Subject: Three Mile Island Nuclear Station, Unit 1 (TMI-1)
Operating License No. DPR-50
Docket No. 50-289
Additional Information in Response to Generic Letter (GL) 95-03
"Circumferential Cracking of Steam Generator Tubes"

GPU Nuclear Response to Generic Letter 95-03 Request for Additional Information

FIGURE 1

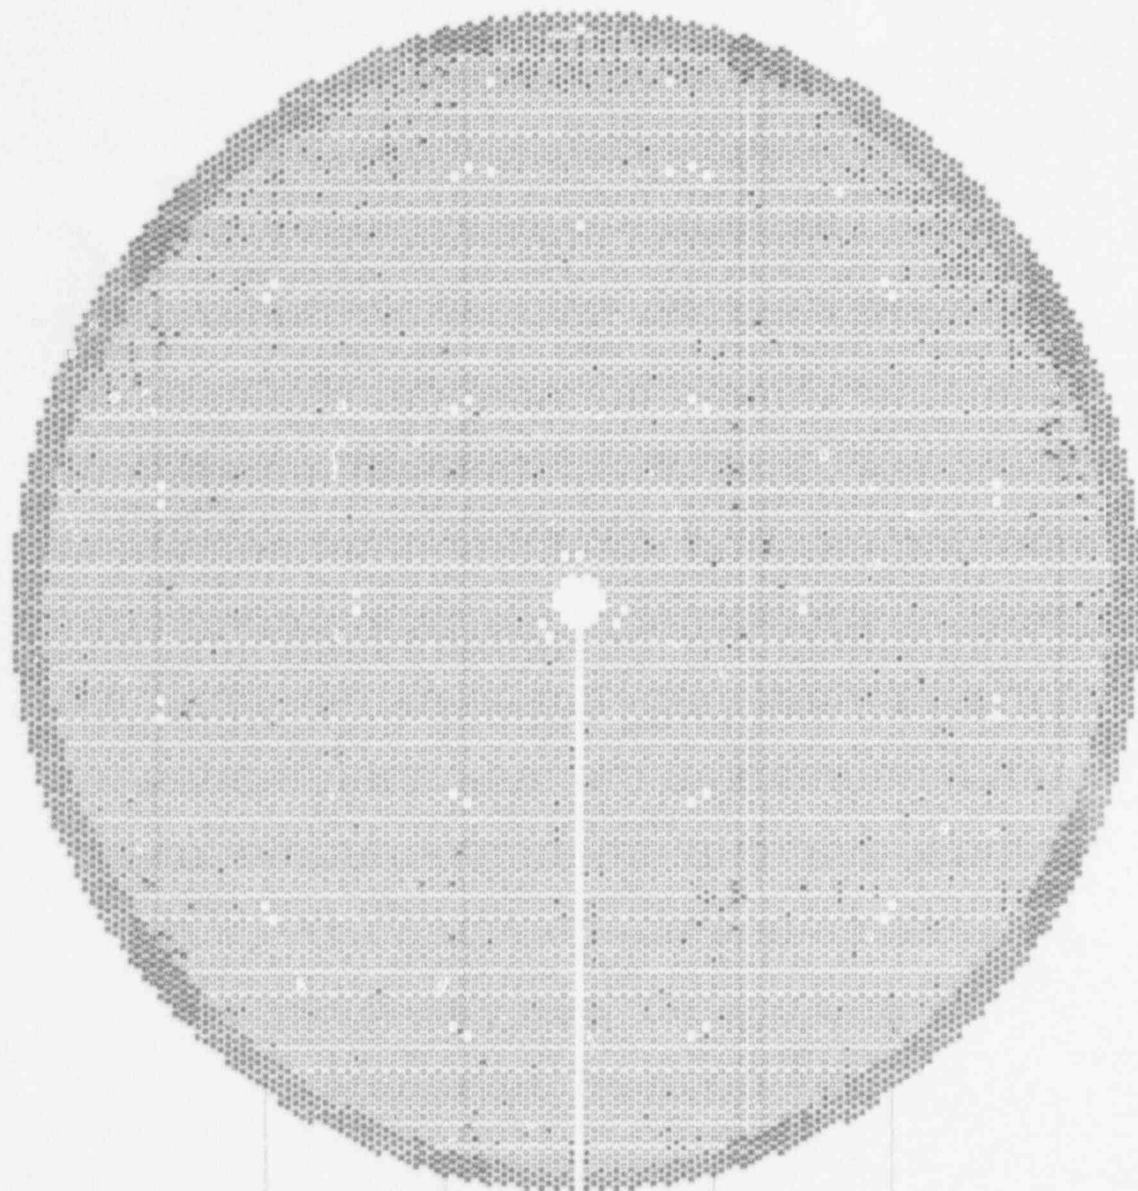
EPRI report NP-6201 indicates that the 15th TSP contains both broached holes and drilled holes, the drilled holes being prone to denting. Please clarify whether all of the tube support plates are of the broached hole designs or whether a number of them contain drilled locations, if applicable, or if it has been observed at other support plate intersections (i.e., broached holes).

The outer tube locations in the 15th tube support plate (TSP) at all units are drilled to a .637" minimum / .646" maximum diameter. Approximately 1621 locations are typically drilled. At TMI-1 1626 locations are drilled in the 15th TSP as shown on Figure 1. All remaining locations at this support plate, and all locations at the other support plates, are broached as described in the GL 95-03 response.

As stated above in response to question #1, at TMI-1 all support plate holes are broached except for 1626 holes in the peripheral holes of the 15th TSP where the holes have been drilled only (See Figure 1).

FIGURE 2A

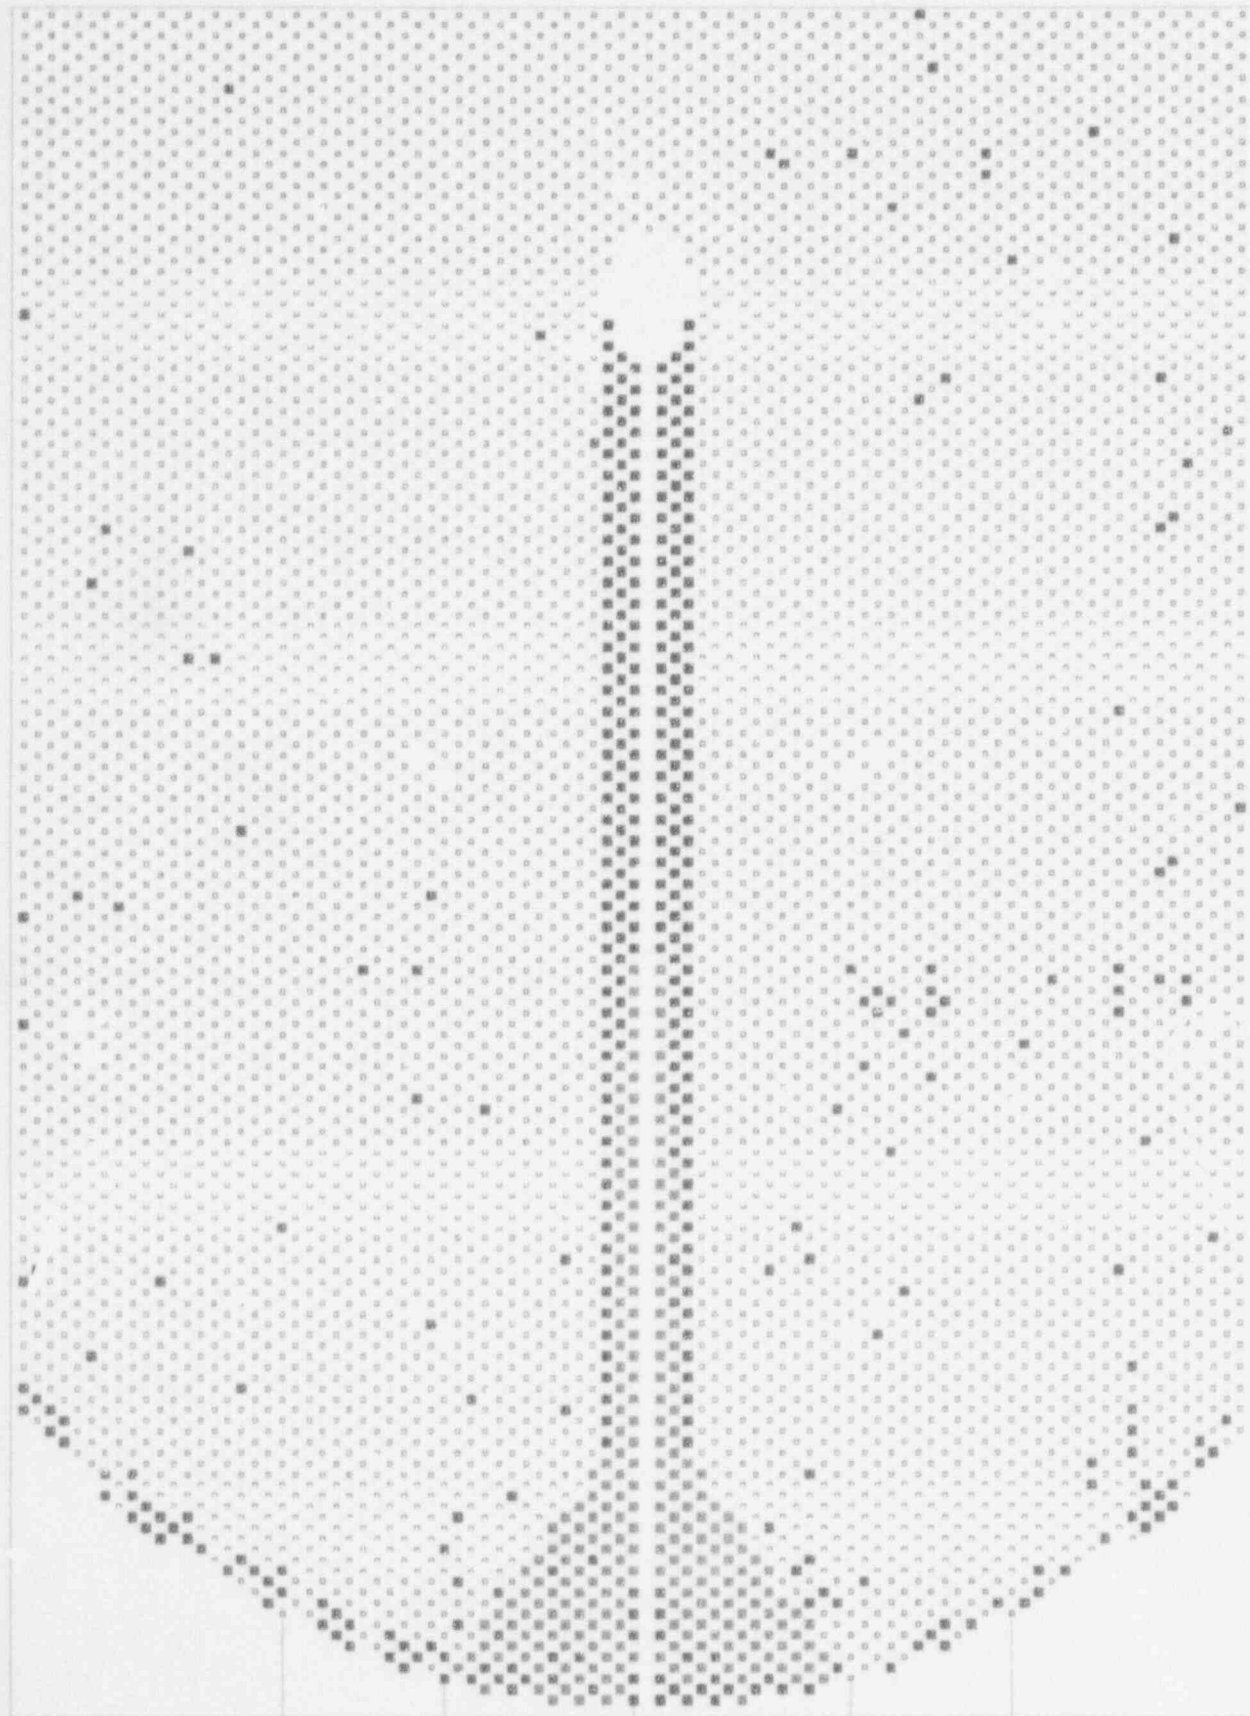
- 1) Please clarify if all tubes in the lane/wedge region have been sleeved at TMI-1.

Tubes along the inspection lane, including an area that fans out at the periphery, are referred to as the lane/wedge region. TMI-1 Tech Spec §4.19.2.a.4(1) defines a group of tubes in the lane/wedge region as "Group A-1," which, along with another group of tubes, may be excluded from the first random sample if all tubes in that group in both steam generators are inspected. Group A-1 is sometimes referred to as the "Tech Spec defined lane/wedge." Un-sleeved tubes in the TMI-1 Tech Spec defined lane/wedge areas of OTSG "A" and "B" are shown in red on Figures 2A and 2B respectively.

The "TMI-1 defined repair lane/wedge" is a region where engineering analysis and OTSG history review has determined that high cycle fatigue cracking is most likely to occur. All in service tubes in the "TMI-1 defined repair lane/wedge" have been sleeved. These tubes are shown in green on Figures 2A and 2B respectively.

FIGURE 3A

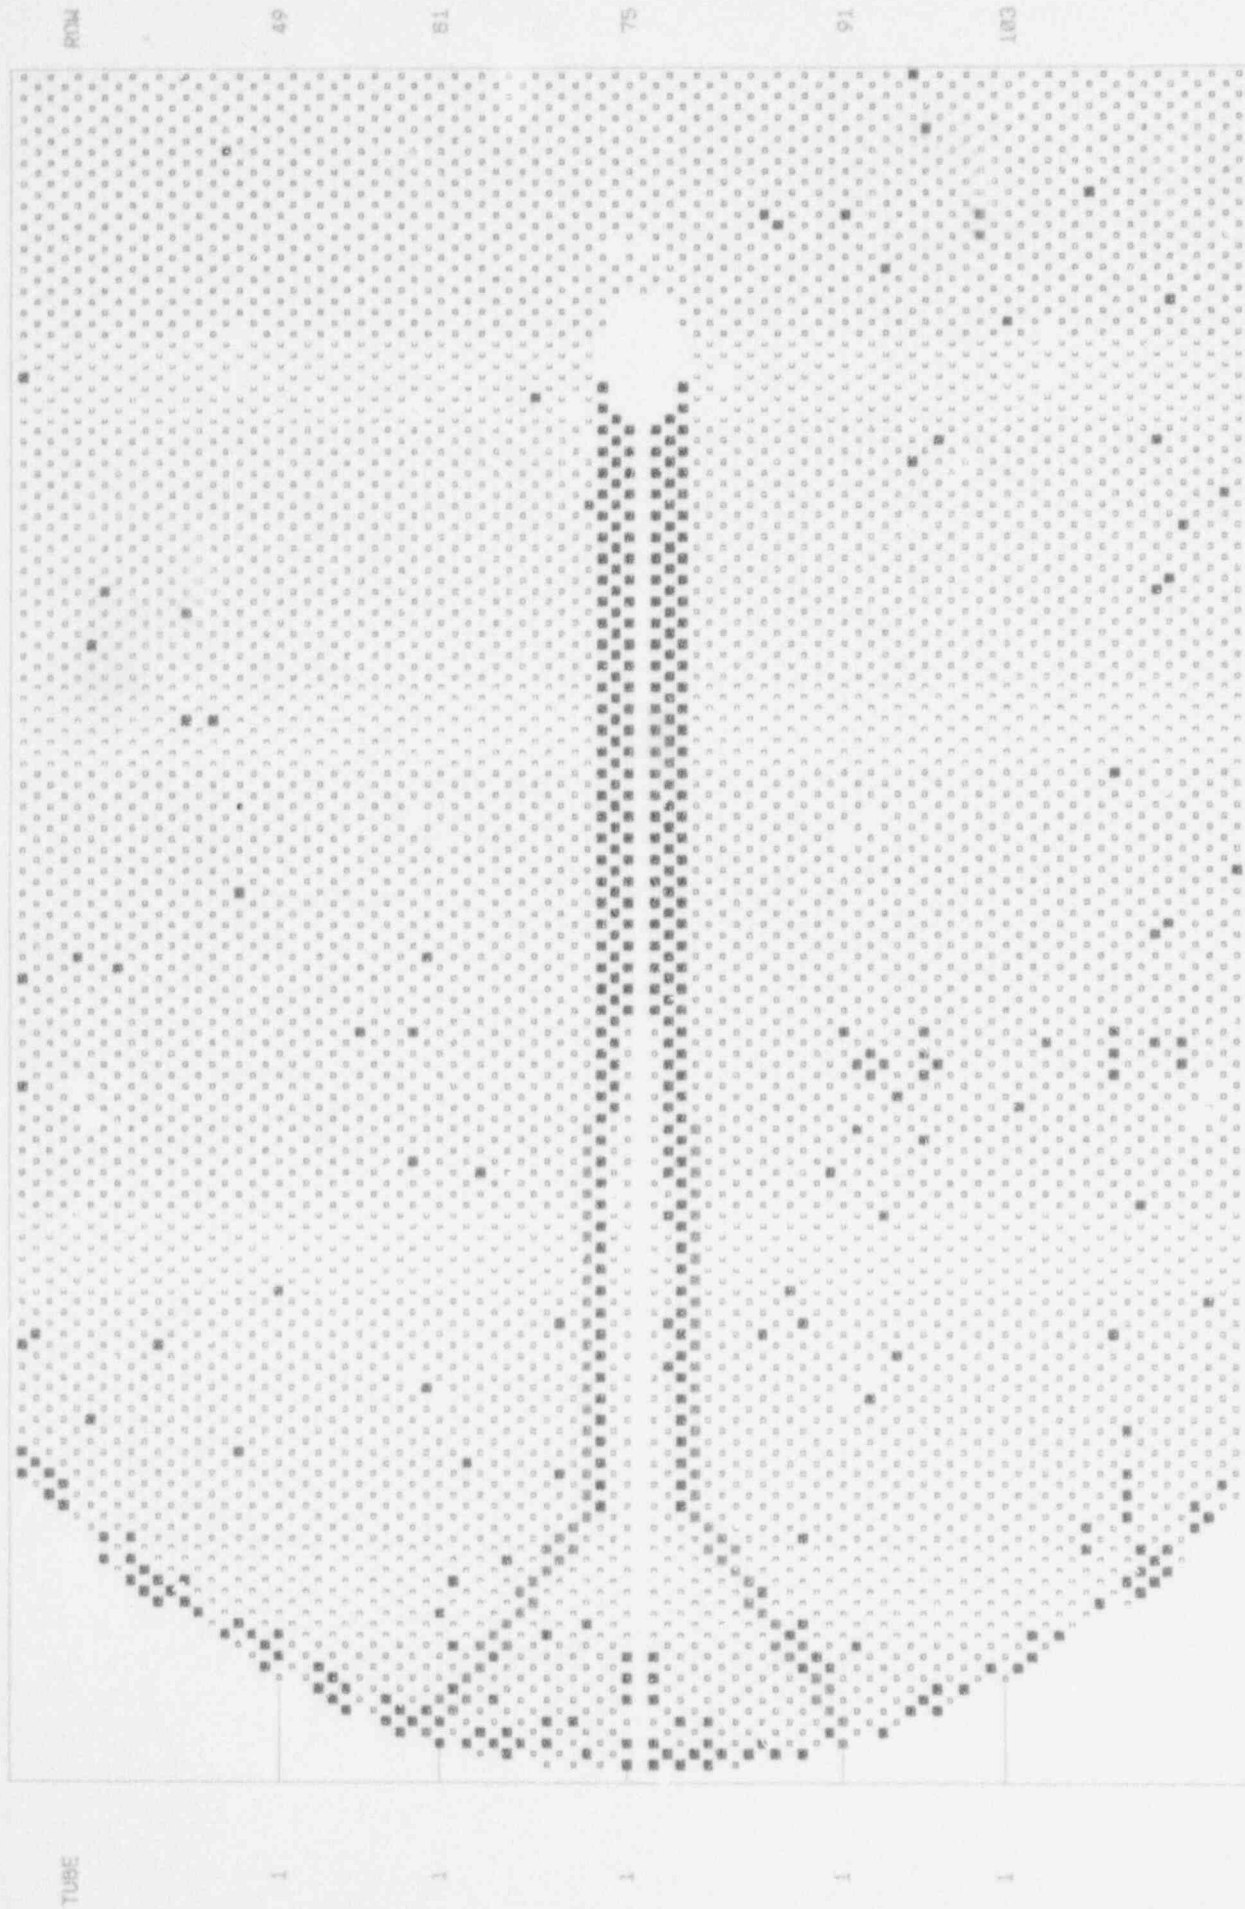
- 2) Please describe the basis for limiting the inspection to the lane region.

- a. Clarify the inspection scope in the lane/wedge region during the last steam generator tube inspections (including the probe type and number (and/or percentage) of tubes inspected).

Figures 3A and 3B show the 589 tubes where 3-coil MRPC examination of the kinetic expansion was performed during 11R. These tubes were chosen because they should be the first to exhibit high cycle fatigue cracking based on highest main steam cross flows and proximity to the previous historical OTSG high cycle fatigue failure locations.

Figures 3A and 3B show the lane/wedge tubes which were examined with the 3-coil MRPC technique during 11R. The 3-coil head contained 0.115" pancake, axial and circumferentially wound coils.
